File No: CHE/18/00411/FUL  
Plot No: 2/2011

## ITEM 2

### PROPOSED ARTIFICIAL TURF PITCH AND ASSOCIATED LANDSCAPING, BOUNDARY TREATMENTS, FOOTPATHS, FENCING AND LIGHTING ON THE SITE OF THE FORMER LEISURE CENTRE WITHIN QUEENS PARK (REVISED PLANS RECEIVED ON THE 03/08/2018 AND 07/08/2018) AT FORMER QUEENS PARK SPORTS CENTRE, BOYTHORPE ROAD, BOYTHORPE, CHESTERFIELD, DERBYSHIRE FOR CHESTERFIELD BOROUGH COUNCIL

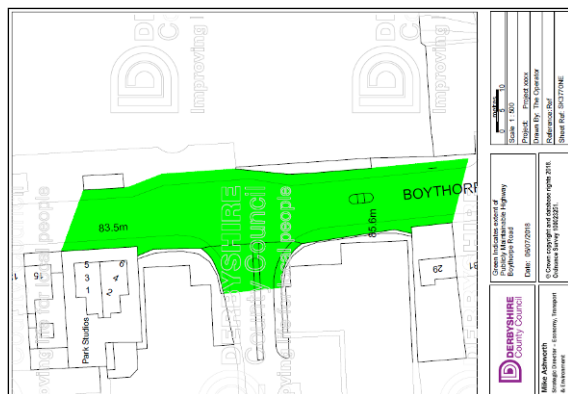
***Floodlights*** - The proposals include the installation of floodlights and whilst drawing Ref 12321.DB3.S01.ZZ.DR.A.20101 Rev P2 shows floodlights M1, 3 and 5 facing away from the public highway the remaining floodlights M2, 4 and 6 face Boythorpe Road. Please clarify how these floodlights will not cause glare and distraction to passing motorists on the adjacent busy classified

*road. The light spillage document does not appear to have been updated to show the revised layout.*

*Additionally any third party external lighting installation adjacent the public highway should be designed and maintained in accordance with ILP 'Guidance Notes for the Reduction of Obtrusive Light GN01 2011'. To fully assess the lighting installations impact on the surrounding environment your Authority may wish to consider a night time survey which should be carried out by a competent independent lighting engineer at the applicant's expense. Please clarify whether or not the above document has been referred to in the preparation of the proposed scheme.*

12. Prior to their installation a revised lighting scheme which takes account of the revised site layout (submitted 03/08/2018 and 07/08/2018) shall be submitted to the Local Planning Authority for consideration. All the lighting columns shall be shrouded to prevent glare to adjoining properties and / or the highway. Only those details which are subsequently agreed in writing shall be implemented on site and retained thereafter as approved.
